South Texas Project Electric Generating Station 4000 Avenue F – Suite A Bay City, Texas 77414

September 14, 2009  
U7-C-STP-NRC-090137

South Texas Project  
Units 3 and 4  
Docket Nos. 52-012 and 52-013  
Response to Request for Additional Information

Reference: Letter, Jessie Muir to Scott Head, "Request for Additional Information, Letter Number Four Related to the Environmental Report for the South Texas Combined License Application", dated August 14, 2009 (ML091620673).

**Figure 1: Schematic of the MCR and the predominant flow path.**

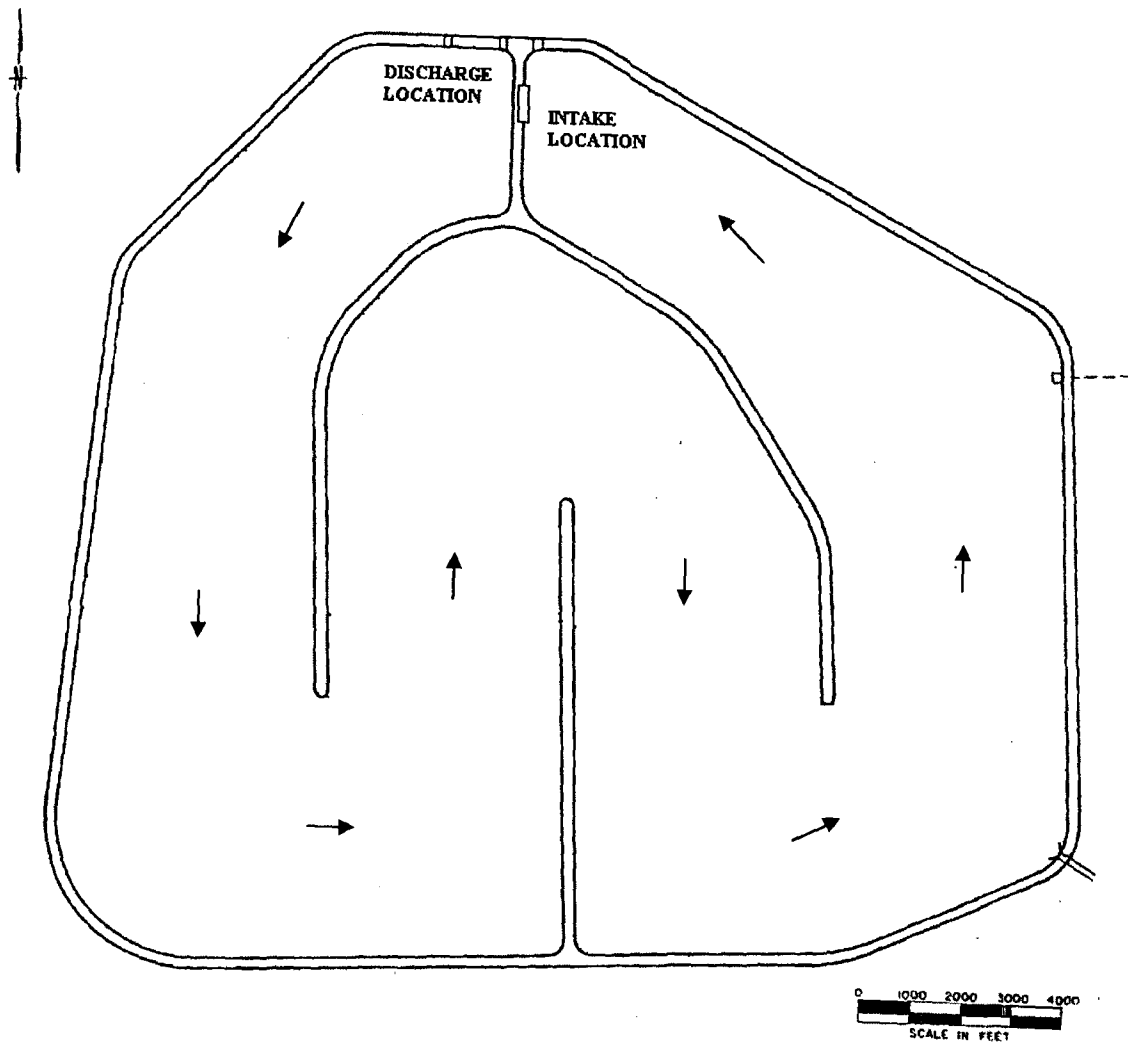
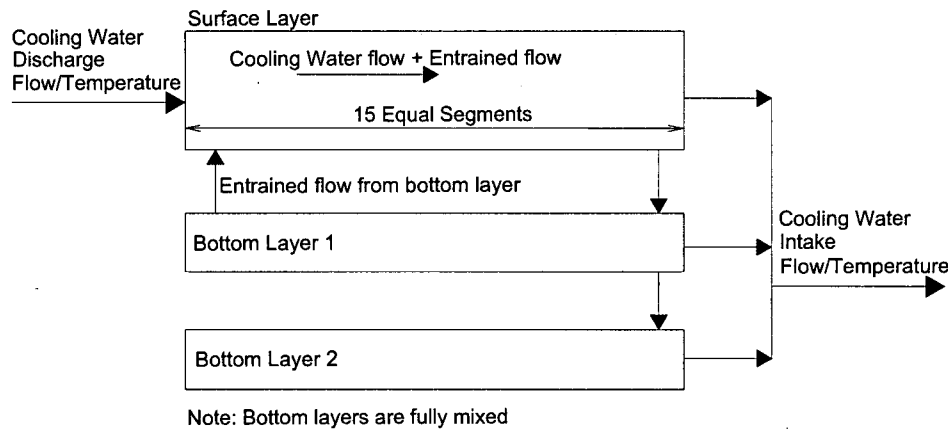
The applicant provided a brief description of the calibration of the MCR thermal model in response to staff's RAI 5.2-4. Provide the following additional information:

The configuration of the MCR (shown in Figure 1) was represented numerically in the model by 15 segments of equal surface area and volume as depicted in the schematics in Figure 2. Each segment contains a surface layer where heat transfer with the atmosphere takes place, and 2 bottom layers to account for potential vertical stratification and the return flow for entrainment at the cooling water discharge. The model calculates the rate of net heat fluxes through the free surface of each segment and by applying the heat and mass balance principles, computes the heat flux into the next segment.

Figure 5.3-1 Summer Salt Deposition

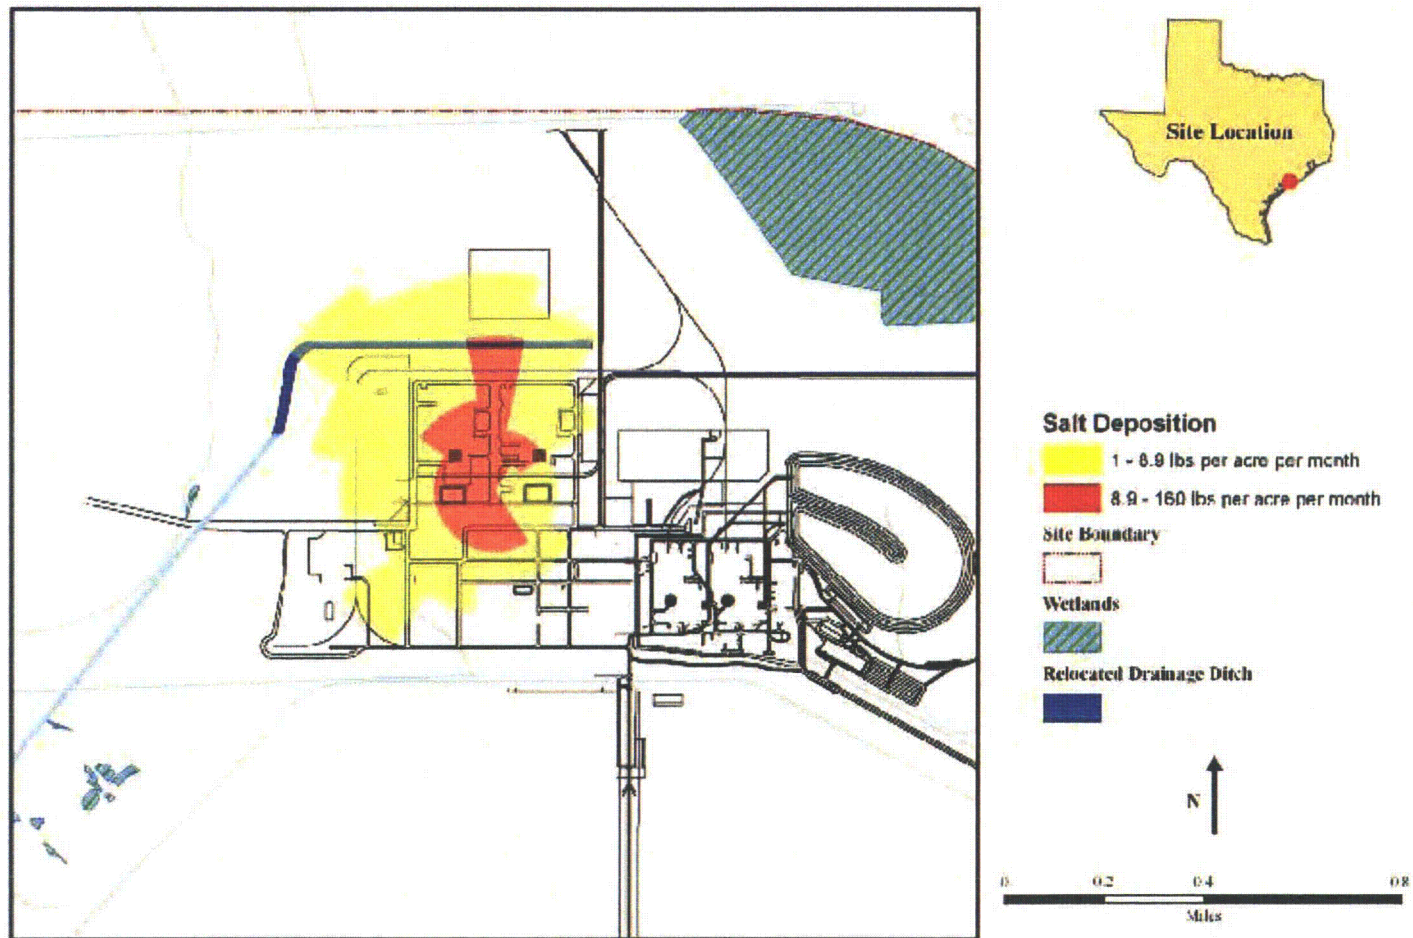
Provide an analysis of UHS cooling tower impacts for normal operation.

The summer season has the maximum deposition rates and the greatest extent of salt deposition. Each of the other seasons and annual salt deposition rates would be bounded by the summer season. As shown in Figure 5.3-1, the rate of salt deposition from the operation of the mechanical draft cooling towers rapidly decreases as the distance from the towers increases. The salt deposition rate falls below the NRC significance limit of 8.9 pounds per acre per month for all locations greater than ~~1300~~ 1600 feet from the towers. The salt deposition rates are greater than 1 pound per acre per month for some locations as far away from the towers as ~~3000~~ 4300 feet. The salt deposition rate for all distances greater than ~~3000~~ 4300 feet would be below 1 pound per acre per month. Salt deposition is only predicted to occur for locations up to two miles from the towers.

As presented in Subsection 5.3.3.1.3, the maximum expected salt deposition rate from the combination of both towers would be 420 ~~160~~ pounds per acre per month during the summer. This maximum rate is approximately 47 ~~18~~ times greater than the approximately 9 pounds per acre per month rate that is considered a threshold value for leaf damage in many species. However, the distance to the maximum deposition is only 0.12 mile (660 feet) from the center of the towers (Figure 5.3-1). No deposition greater than 8.9 pounds per acre per month would occur beyond 1300 ~~1600~~ feet (0.25 ~~0.3~~ mile), thus all deposition above 8.9 pounds will occur within the site boundary and most of the deposition will occur on facilities rather than vegetation. As previously discussed, the vegetative cover in the vicinity of the cooling towers is either mowed areas or bluestem/sea myrtle habitat found on previously disturbed agricultural lands, both marginal habitat for most wildlife. Any impacts from salt drift on the local terrestrial ecosystems would therefore be SMALL and would not warrant mitigation. Cumulative impacts are discussed in Section 10.5.

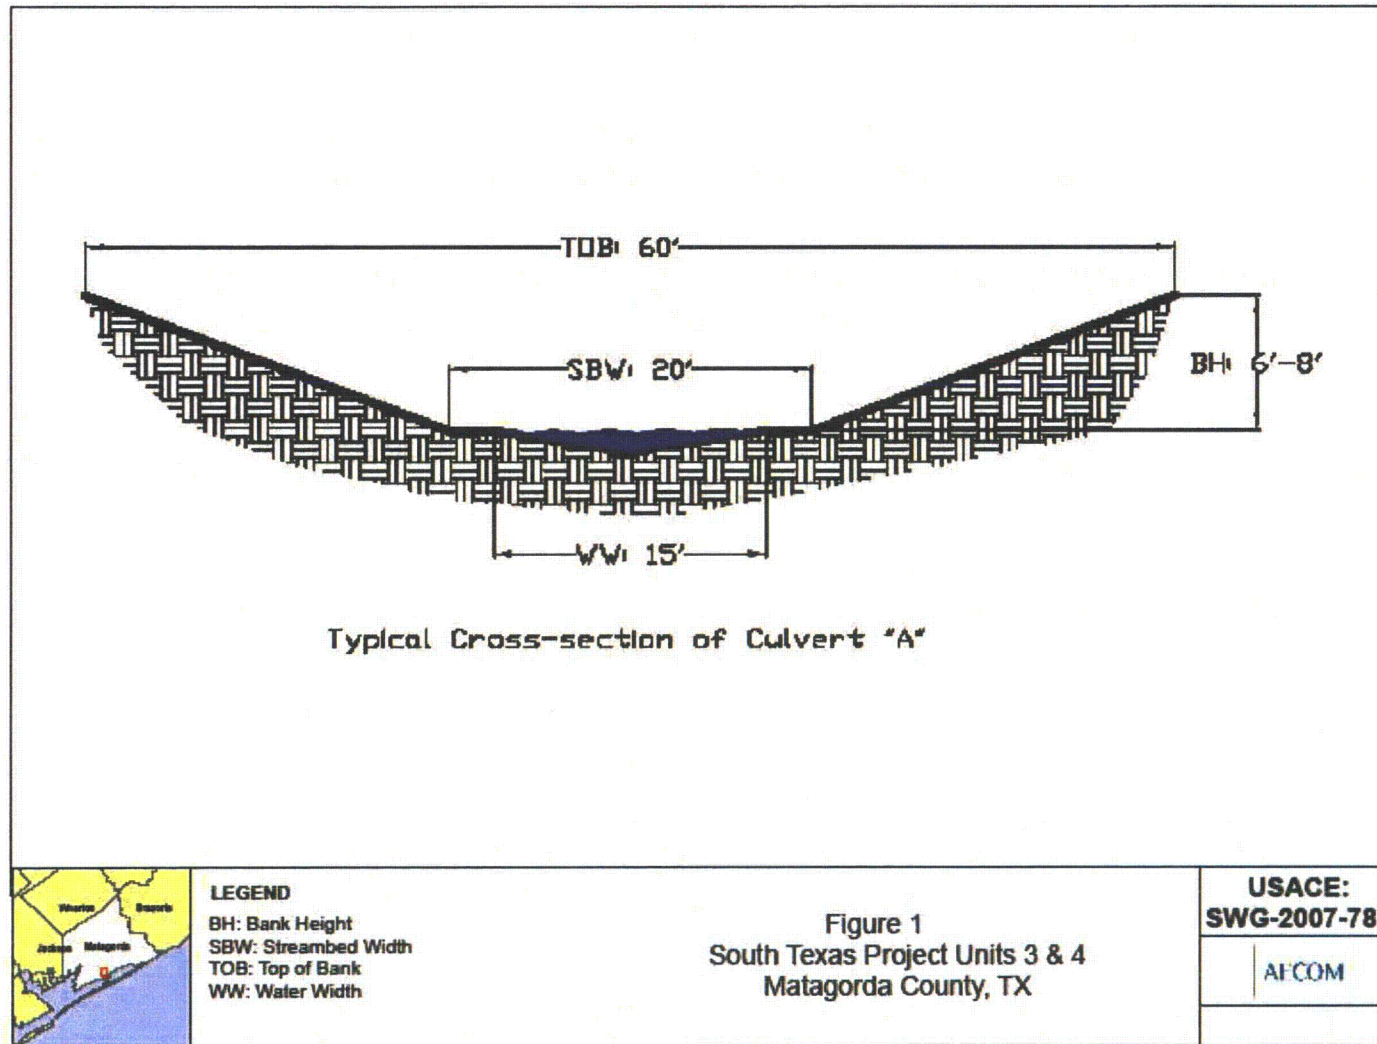
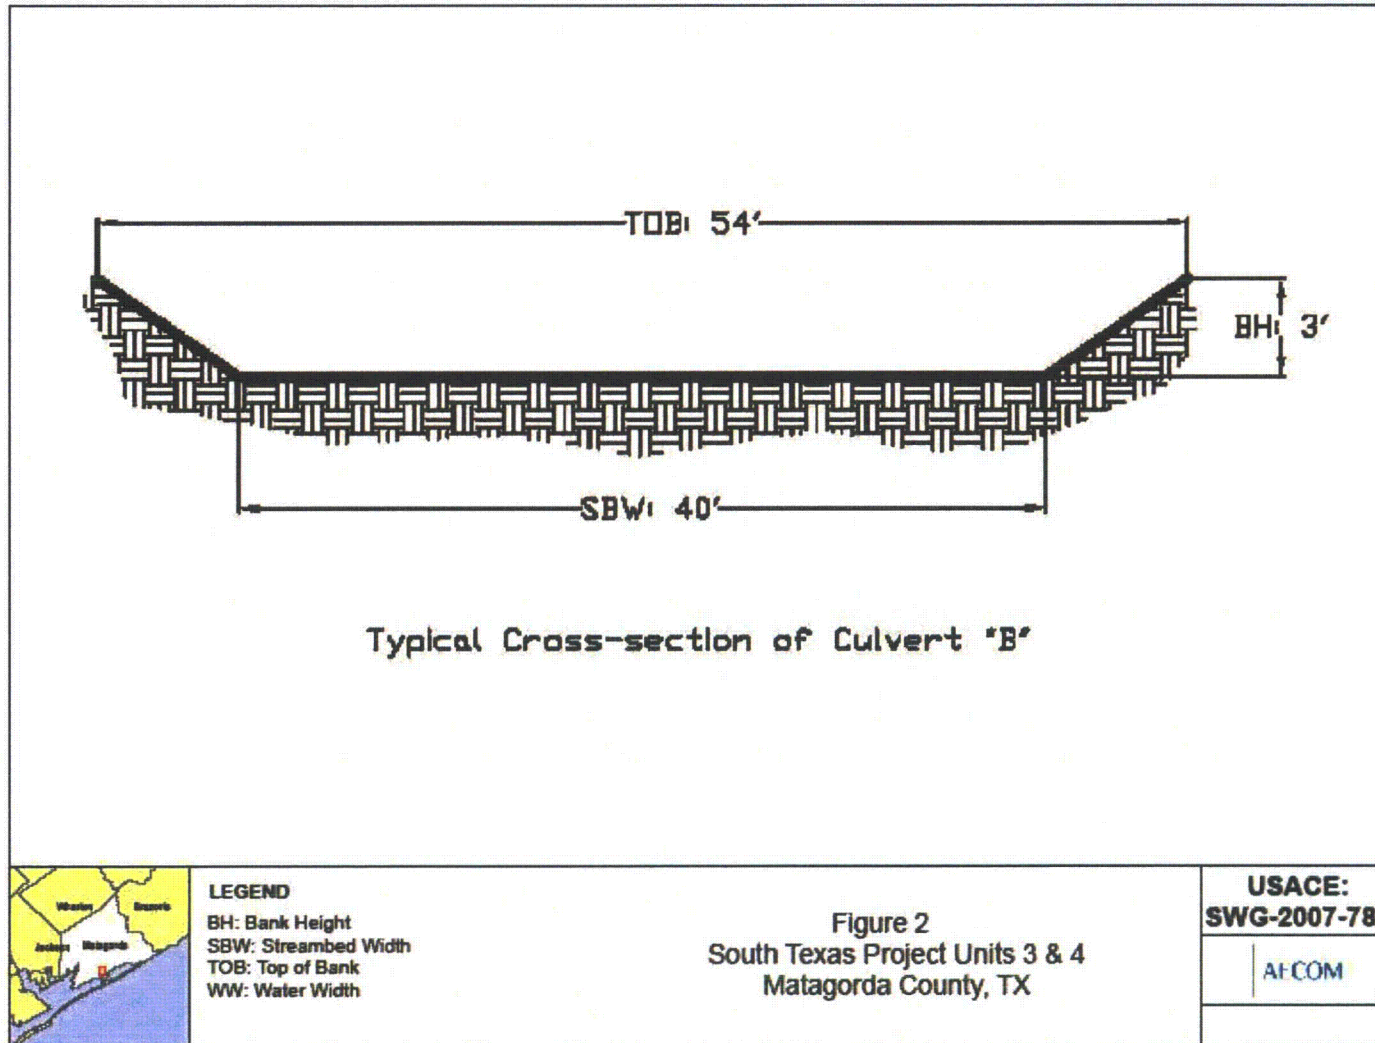
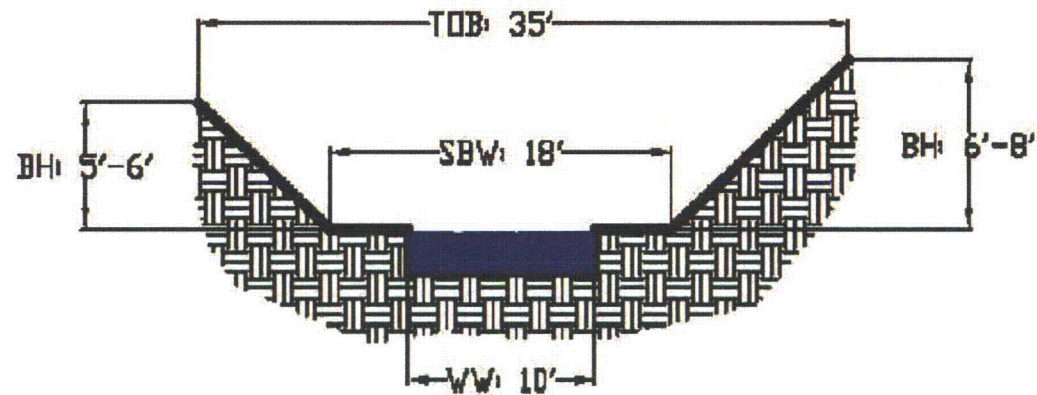
- (1) a plan and elevation drawing showing the general and specific site location and character of all proposed activities, including the size relationship of the proposed structures to the size of the impacted waterway and depth of water in the area drawings of the proposed construction and their impacts to waters of the United States;

- (2) a description of the type, composition and quantity of the material to be dredged, the method of dredging, and the site and plans for disposal of the dredged material;

- (1) STPNOC plans to install six culverts within six existing site drainages associated with the construction of new roadways for this project. Three of the proposed road crossings have existing culverts, however, these will be replaced to support new construction vehicle traffic. Figure 3.9S-1 in the Construction Utilization Plan in Rev 3.0 of the Environmental Report depicts site locations for each of the proposed activities. Figures 1 through 6 depict cross

sections for Culverts A, B, C, D, E, and F and illustrate the existing profiles and information related to the crossing width, depth of water, water width, and bank height for each location. A cross-section for Culvert G is not included because it is associated with a drainage ditch to be dug wholly and totally in uplands and consequently has no jurisdictional impacts.

(2) Each crossing will be excavated to proper elevation and then culverts will be placed accordingly to maintain flow conditions within each drainage. Excavated materials will be transported to and stored in one of the existing on-site soil stockpiles. Site assessments were conducted in August 2009 to document ecological conditions associated with each crossing location.
